Design and Heritage statement  
 2 storey rear extension

No.58 Denmark Street Diss IP22 4BE

## Pre application Feedback initial scheme

ENQHOU/2023/0329

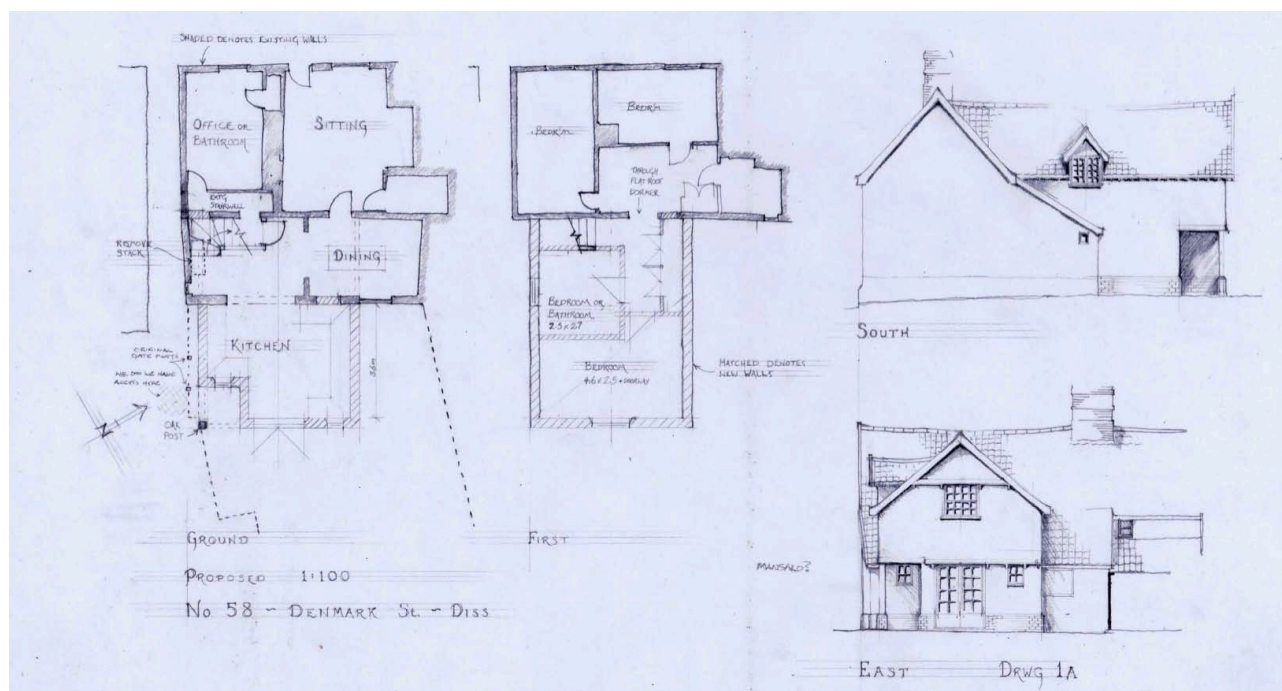
The overall general form and details of the extension are fine but having visited the site I feel that the extension is rather too wide and needs to respect more the massing of the main part of the house, which is slightly narrower. Also, since our last telephone discussion I have looked at the details of the previous 2014 approval where I see there was an issue with the impact on light levels with the neighbour at the north side, requiring the extension to be reduced in length. Whilst the proposed extension has been moved slightly southward this is by quite a small amount and therefore the issue of loss of light I think is still an issue. Reducing the length of the extension is therefore likely to provide a more acceptable scheme. With the above amendments to the size of the extension some additional space could be provided at the ground floor by a small lean-to at the north side and/or a lean-to at the rear gable end as was previously approved.

We discussed cutting through the existing wall plate for first floor access and also the alterations required to the existing stair. If the stair is very early and largely intact there may potentially be an issue with the level of alteration required for the new extension so I would need to take a look at this to make a proper assessment of the impact of proposals. The section of wall plate where the new opening is proposed does not appear to show any peg holes for the studs so there has possibly been some alteration here or it may just be that the original wall plate has been covered over. I would not necessarily object to removal of the wall plate section, but I would need to take a look at the overall arrangement of the house before confirming whether or not cutting through it is likely to raise any issues

We did discuss a potential overlooking issue with the proposed new side dormer. Having further considered this, if this is to serve a bathroom then having obscure glazing and single opening light at the east side would I think be sufficient to address the issue. With regard to the length of the extension this needs some reduction in order to address issues with reduced light levels at the neighbour's side to the north. These changes would provide a more acceptable scheme to meet the requirements of policy DM3.13 of the Local Plan 2015.

Due to the historical importance of the existing staircase, this negates the need for a new staircase (as shown initially), however access to the extension would be via the flat roof dormer. Combined with the narrowing of the gable and a traditional pitch roof, this allows the buildings ridge (overshadowing point) to be moved as far South West as possible.

The gable width and pitch now matches the original C17th roof, which squeezes in 2 much needed bedrooms.
